PFR-105 Title: SPB Turns Counter Faliure

Assembly : THM-SPB-MEC-001	SubAssembly : THM-SPB-MEC-500	
Component : THM-SPB-MEC-500	Units Affected:	Units fixed:
Originator: Dalton	<input checked="" type="checkbox"/> <input checked="" type="checkbox"/> <input checked="" type="checkbox"/> <input checked="" type="checkbox"/> <input checked="" type="checkbox"/> <input checked="" type="checkbox"/>	<input type="checkbox"/> <input type="checkbox"/> <input type="checkbox"/> <input type="checkbox"/> <input type="checkbox"/> <input type="checkbox"/>
Organization: SSL - UCB	Date: 10/10/05	
Phone: 510.643.9240	Email : gdalton@ssl.berkeley.edu

Fig1. Meter Wheel Assembly

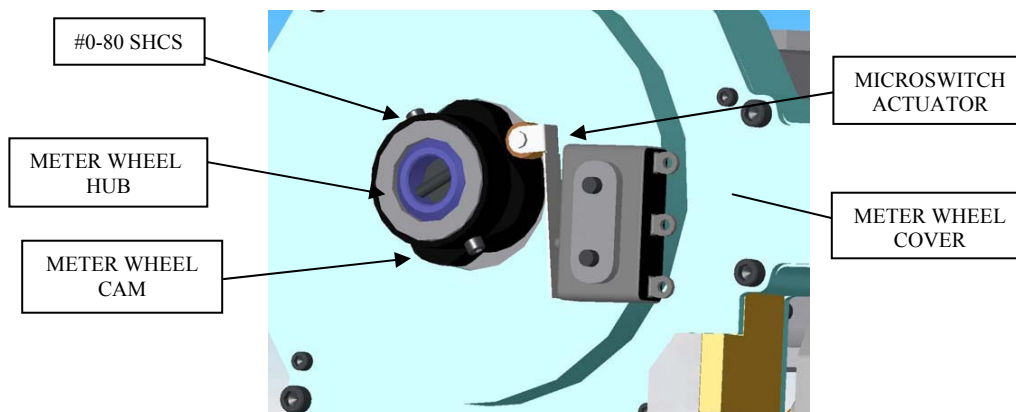
During EFI suite level integration on F4, the turns counter was indicating only half the number of turns on two of the SPB's.

This problem was verified by visually counting the turns and also by measuring the length of cable off the spool. All indications were consistent with the hypothesis that the turns counter was clicking on only half the lobes of the *Meter Wheel Cam* (see fig. 1). While observing the cam, the SPBs were run and it was noted that the roller actuator on the microswitch was riding on top of the 2X #0-80 SHCS that hold the *Meter Wheel Cam* on the *Meter Wheel*. This would cause the Turns Counter to report only half the number clicks. It was also determined that the microswitch actuator could have been bent during a re-stow evolution, causing the actuator to fall off the cam path and onto the SHCS.

The #0-80 SHCS will be replaced with PHS, which are only half the height and will clear under the *Microswitch Actuator* roller as the cam rotates.
